# UNITED STATES PATENT AND TRADEMARK OFFICE

APPLICATION NO.	FILING DATE	FIRST NAMED INVENTOR	ATTORNEY DOCKET NO.	CONFIRMATION NO.
10/511,070	10/12/2004	Steven Victor Jones		8765

<b>Office Action Summary</b>	Application No. 10/511,070	Applicant(s) JONES, STEVEN VICTOR	
	Examiner Katherine W. Mitchell	Art Unit 3677

## **DETAILED ACTION**

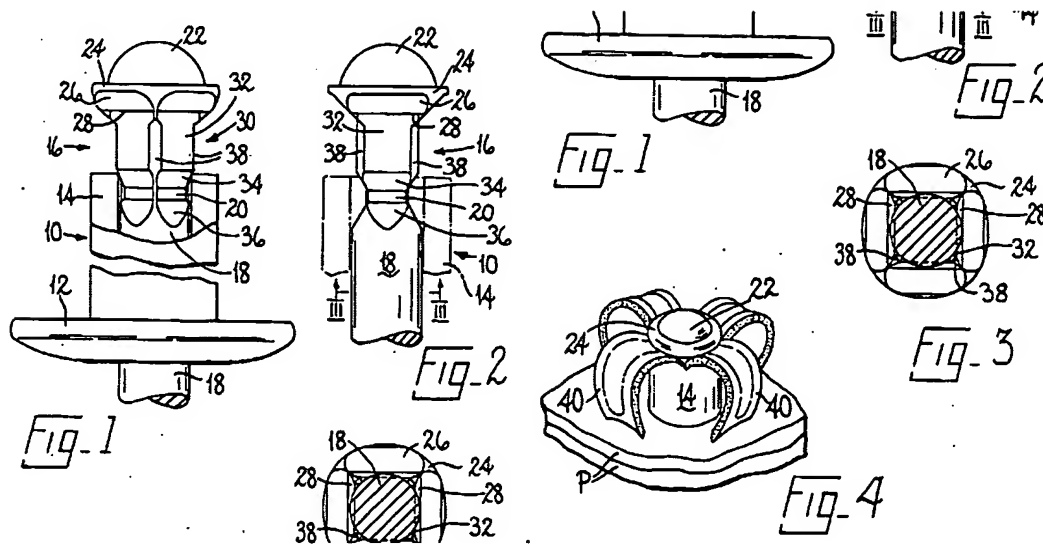
Re claims 1-2: Potzas in Figs 1-4 (above) teaches Potzas teaches a peel type blind rivet (abstract) settable in soft material, having an elongate body 10 with a shank and preformed head 12 at one end, and a plurality of slots 12 terminating at the end remote from the head. There is a mandrel (16, column 2 lines 49-50) having a stem (18) which extends through coaxial with said body and having an enlarged head (22) with a maximum external diameter greater than the internal body diameter (Figs above). The mandrel head forms a shoulder between the mandrel stem and an outer surface of the head, -- the deforming means (head) presents a substantially flat surface perpendicular to an axis of said mandrel, in that the underside of head 22 terminates in plane forming flat shoulders 28 normal to axis of stem, which as shown in Figs 1- 4 and discussed in column 2 lines 62-68 is described as "flat shoulders 28 normal to the axis of the mandrel".
